Safety Evaluation Report

Related to the License Renewal of
the Joseph M. Farley Nuclear Plant,
Units 1 and 2

Docket Nos. 50-348 and 50-364

Southern Nuclear Operating Company, Inc.

UNIT 1 HOOP TENDONS
ACTUAL FORCE TREND PER TENDON BASIS
(from past 6 surveillances)

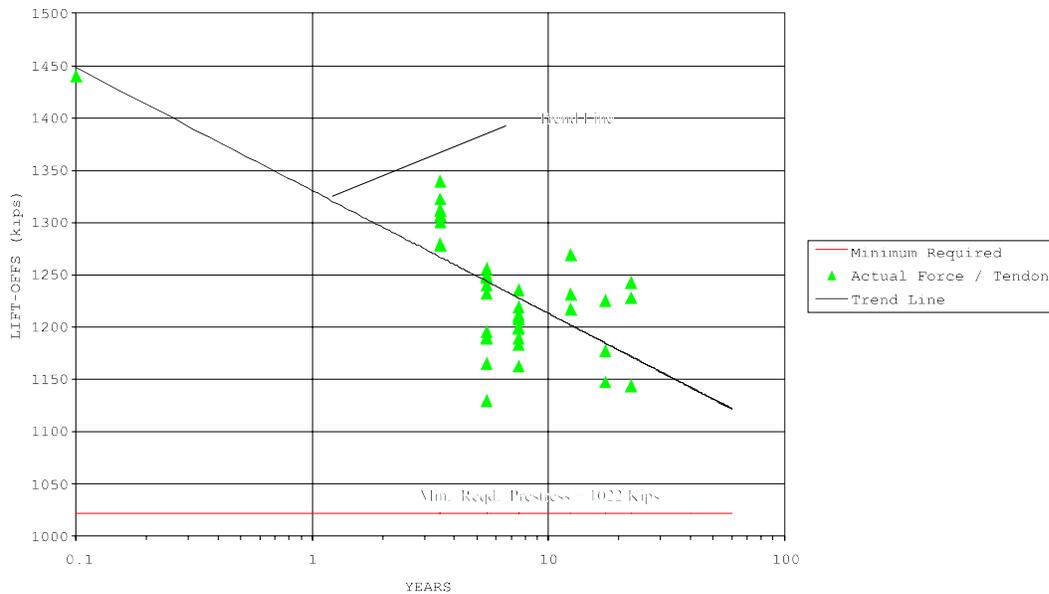
The staff recognizes that subsequent inspections could result in a change in the trend line slopes. However, the applicant will manage this attribute by its Containment Inservice Inspection Program. On the basis of the additional information provided by the applicant, as well as the staff's evaluation, the staff considers the applicant's TLAA related to prestressing forces in the prestressing tendons of the FNP containment to be acceptable.
